Re: License No. SUA-708

In accordance with our commitment dated June 13, 1986, Homestake Mining Company hereby submits 6 copies of its Tailings Stabilization and Site Reclamation Plan for the Grants, New Mexico Uranium Mill and Tailings Facilities. This plan addresses the design criteria and cost analysis as required under Title 10 CFR 40, Appendix A. It addresses mill decommissioning, land cleanup and complete tailings reclamation. It includes activities for interim stabilization to control dusting under 10 CFR 40, Appendix A, Criterion 8. It addresses the control of non-radiological protection criteria through extensive ground water protection programs as required under 10 CFR 40, Appendix A, Criterion 6.

**Tailings Stabilization
and Site Reclamation Plan
License No. SUA-1471
Docket No. 40-8903**

REVISION
OF
FIG. 9

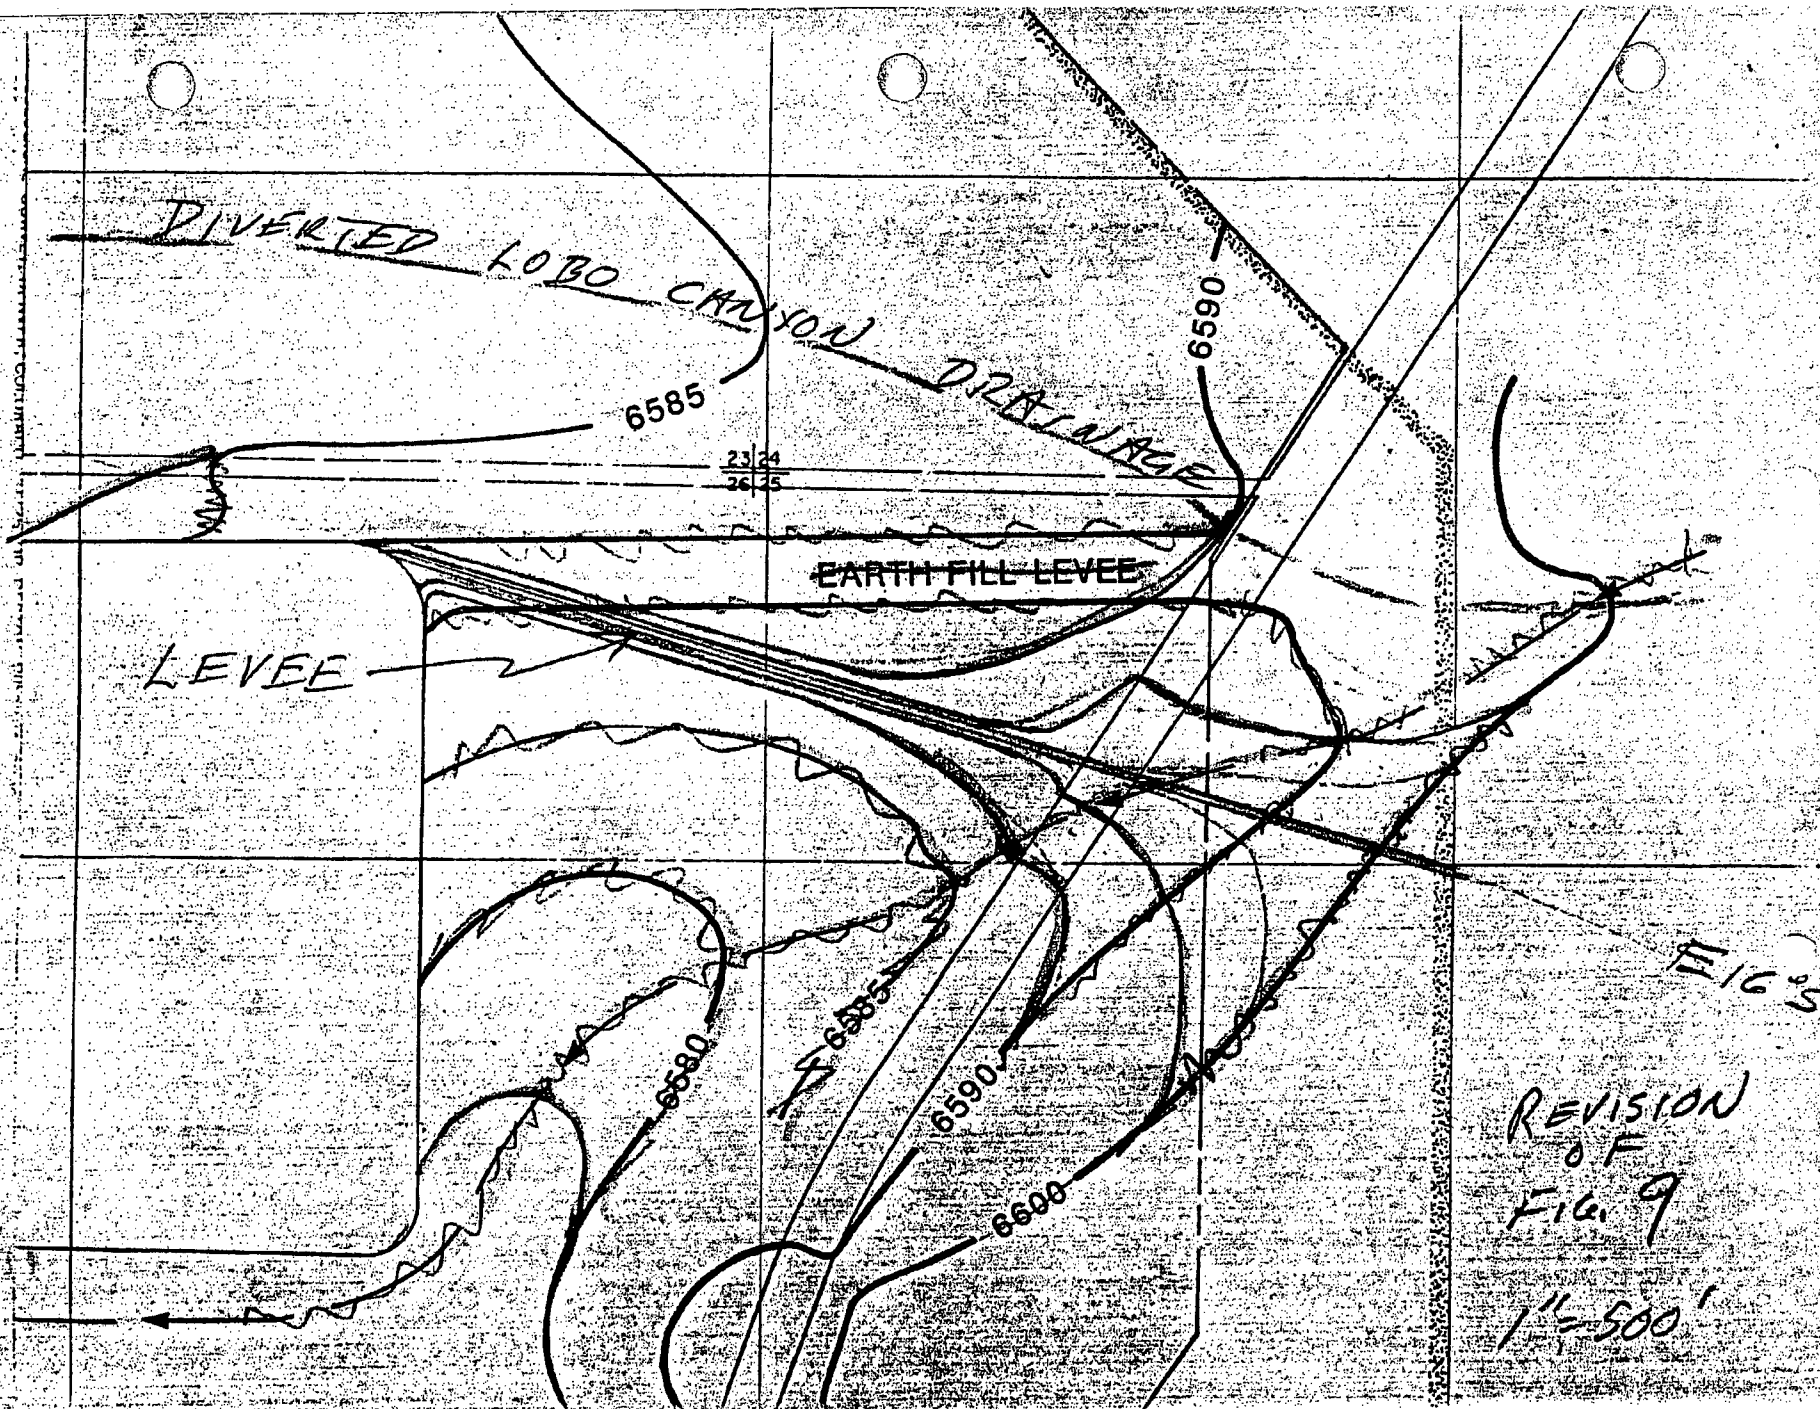
1.a. The levee at the northeast corner of the embankment has been realigned to run E 16 S to take better advantage of existing topography and to minimize or eliminate off-site cut and fill. The poorly defined course of the Lobo Canyon drainage will be rechannelized north of the impoundment. These changes are shown on the attached sketch of the Fig. 9 revision, in which pink highlights the scrub-outs, green the levee crest, and solid blue the revised contours. Figure 12 will also be revised to reflect these changes, as shown on the attached sheet. The flood routing will determine what crest elevation is needed, but at this time the levee is being designed for 3:1 (H:V) slopes and a 20 foot wide crest at elev. 6605. Fill will be sandy soil excavated for Lobo Canyon drainage rechannelization and compacted to at least 105 pcf dry density.

Fig 12

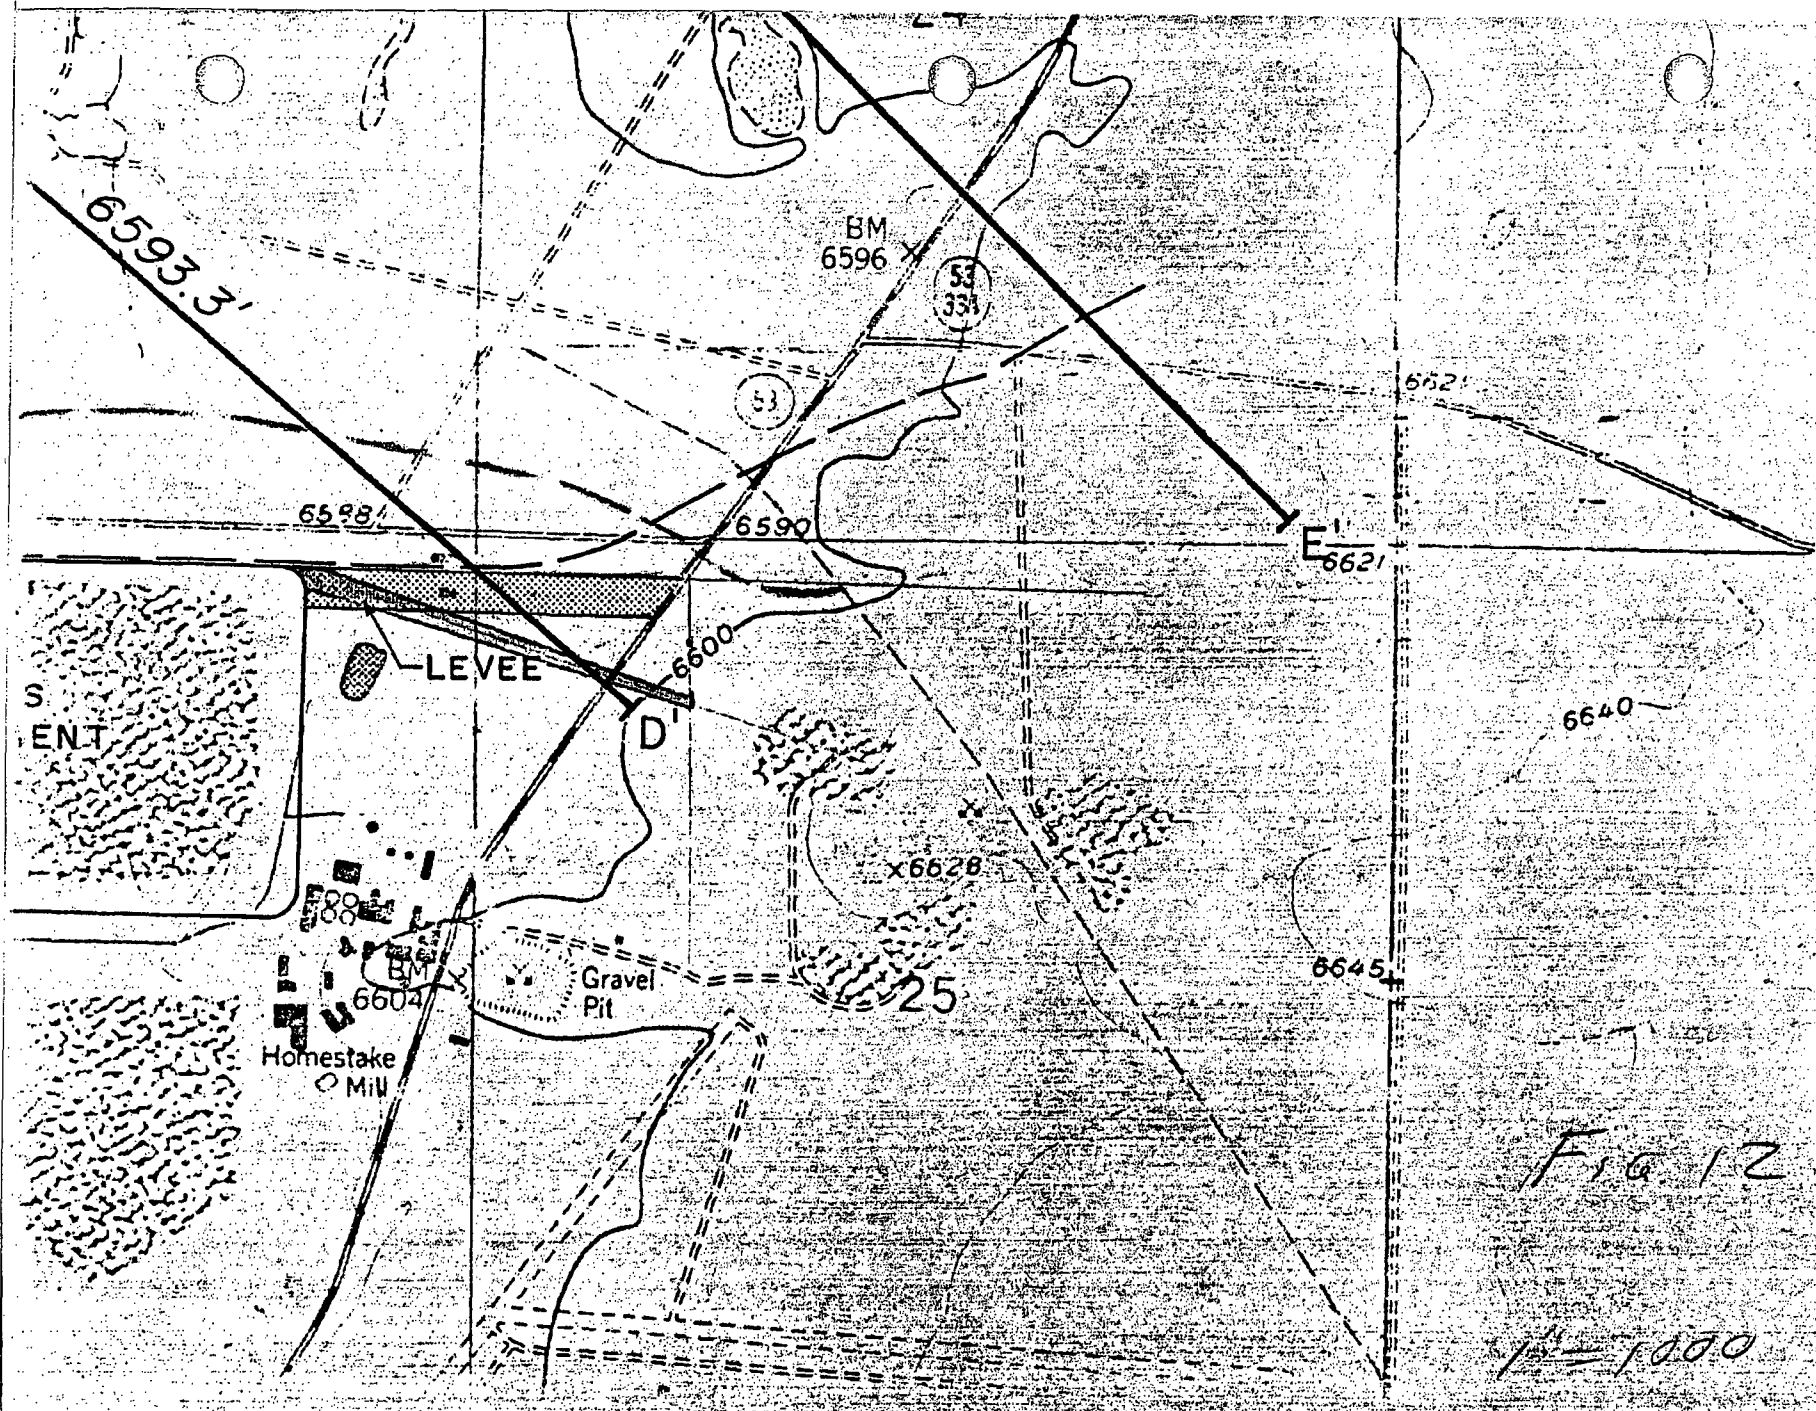
2. The attached letter explains the development of the cross sections used in the HEC-2 analyses. The topo maps used are listed and are available from the USGS in Denver.
